Honor Charter School - No. EP-27-0008

Good morning Amy, I'm following up on my voice mail from yesterday about the Honor Charter school located in El Paso County, town of Peyton.

**FIELD EXPLORATION PLAN
(AERIAL)**

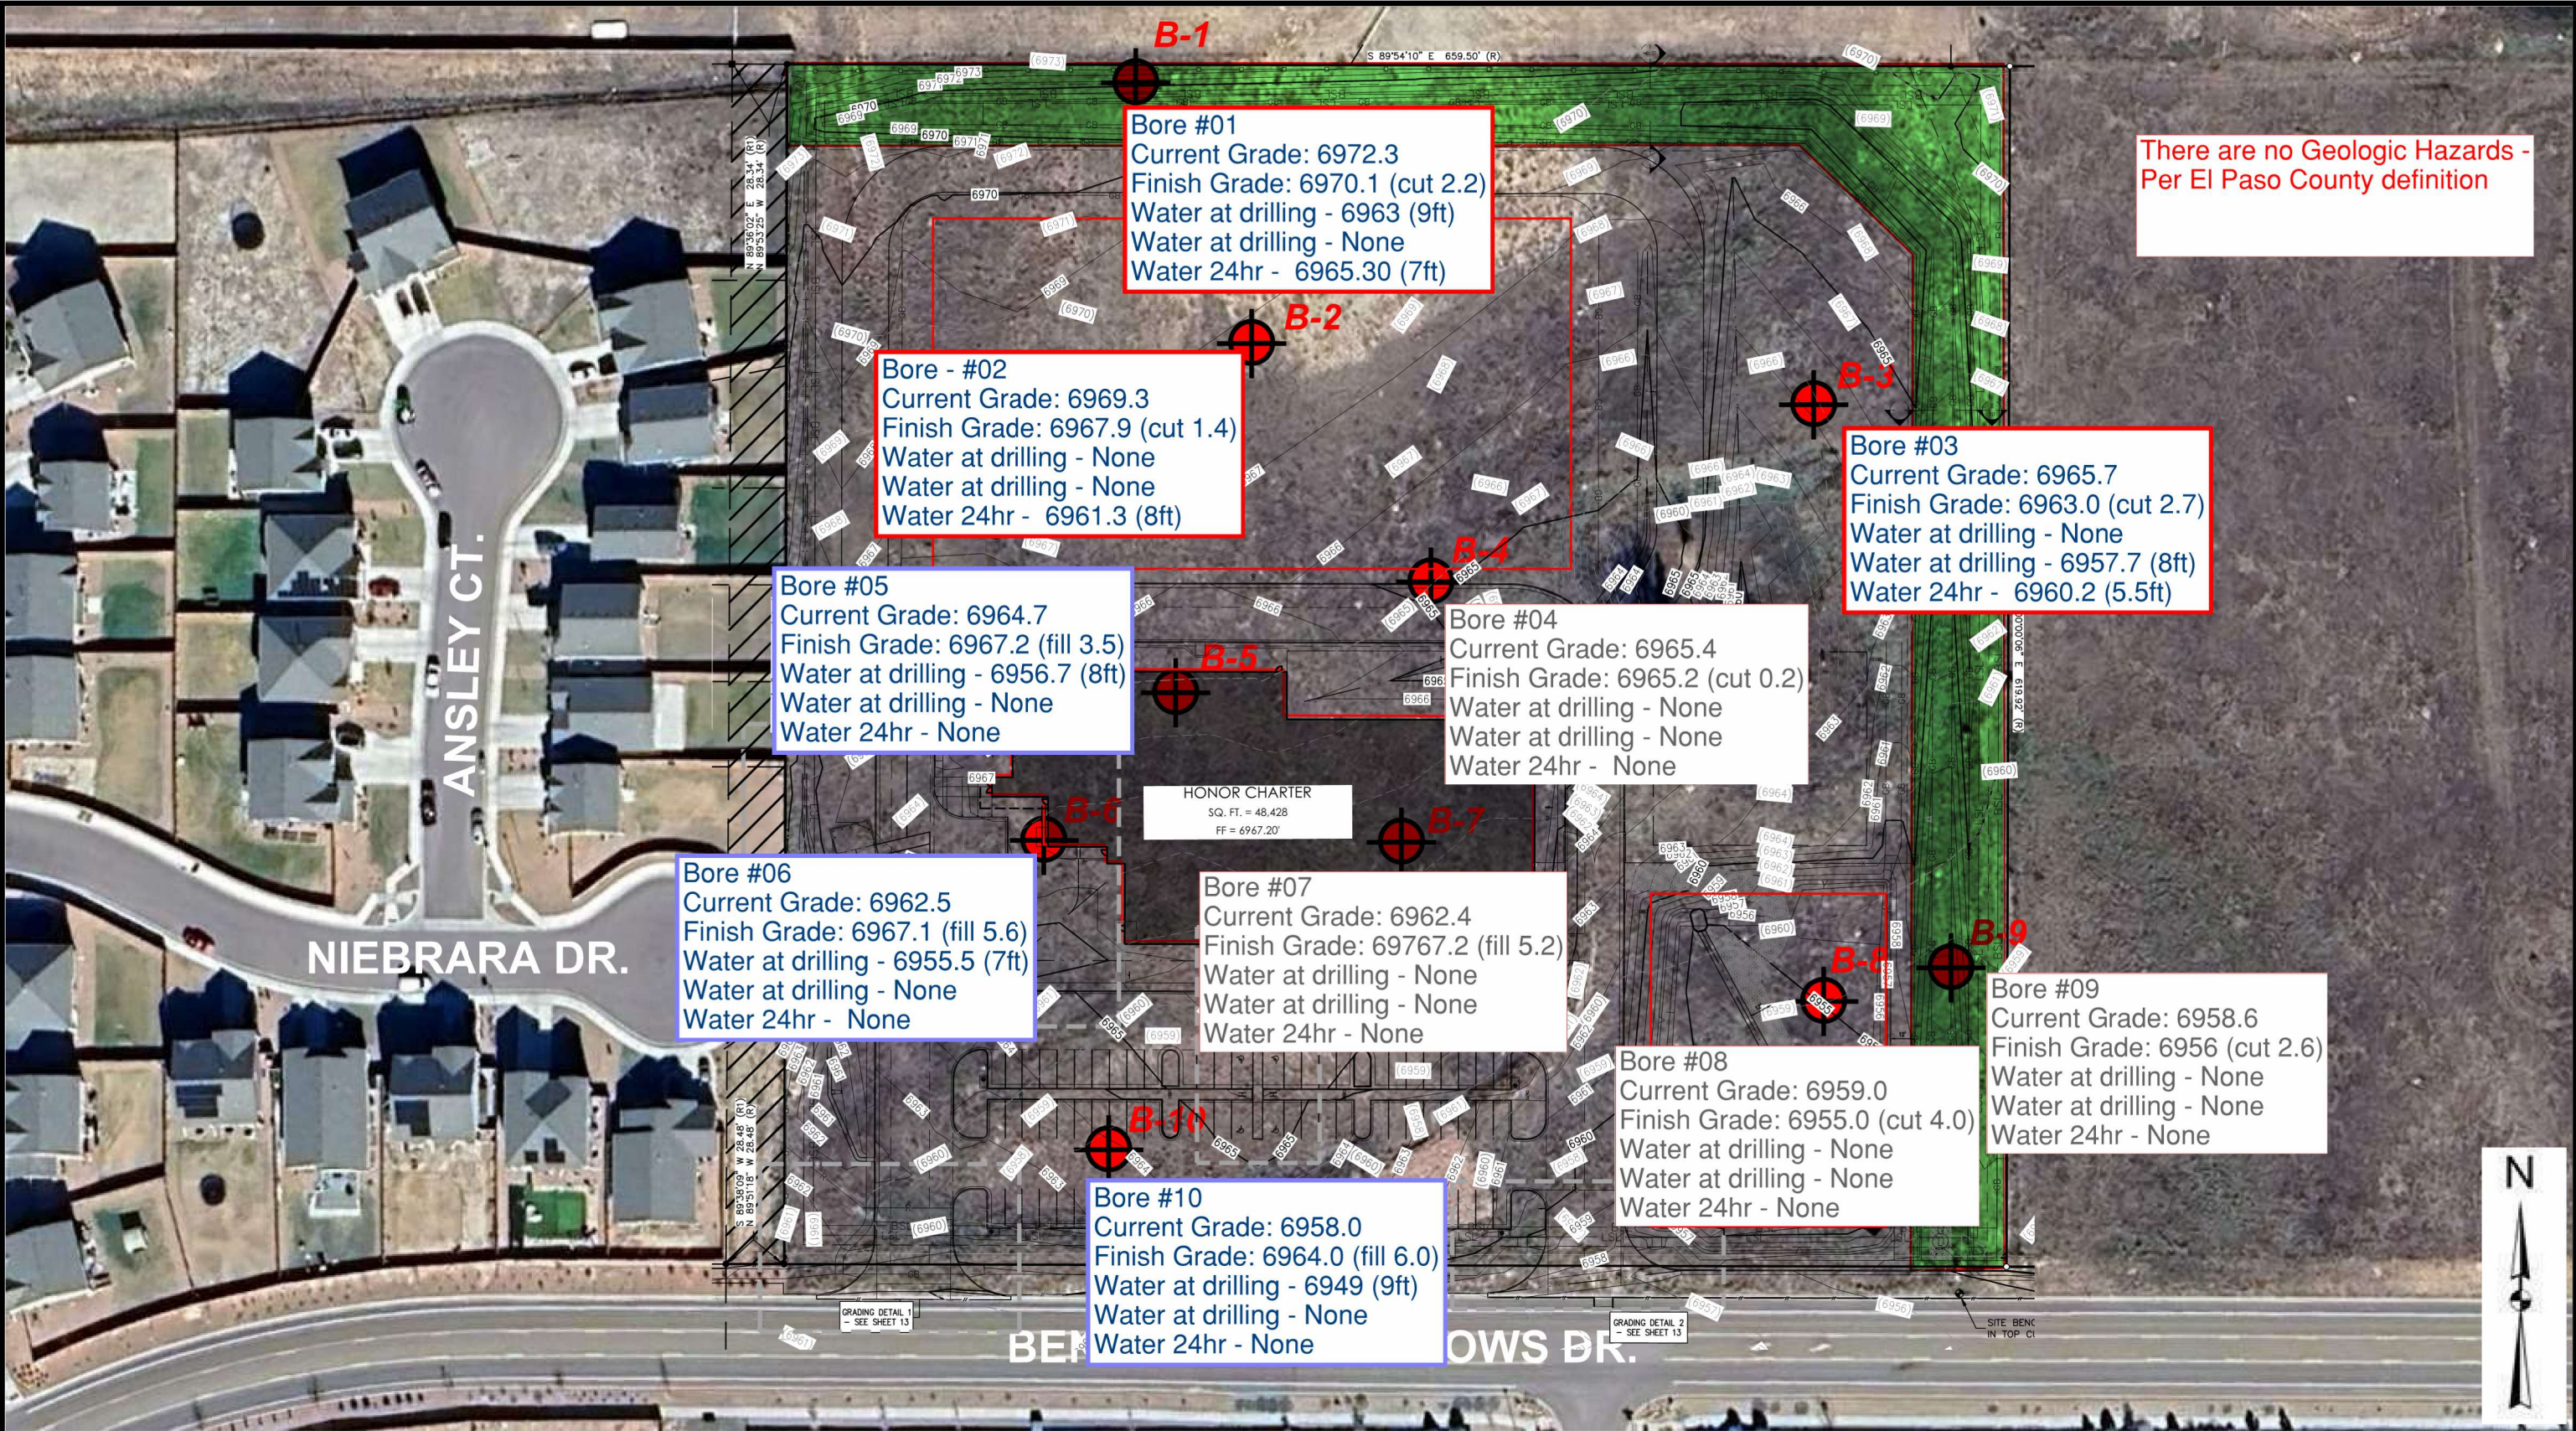
Attached is an updated site plan with the Bore info and grading plan added, I'm hoping this will address item 1 and support 3 & 4.

I'm a visual person (because I think it helps see solutions) so I used the text colour to indicate ground water - Blue for water and gray for no water (even after 24hrs)

I think used the box frame to indicate cut/fill at the bore that had water - red being cut (caution) and fill purple (consider)
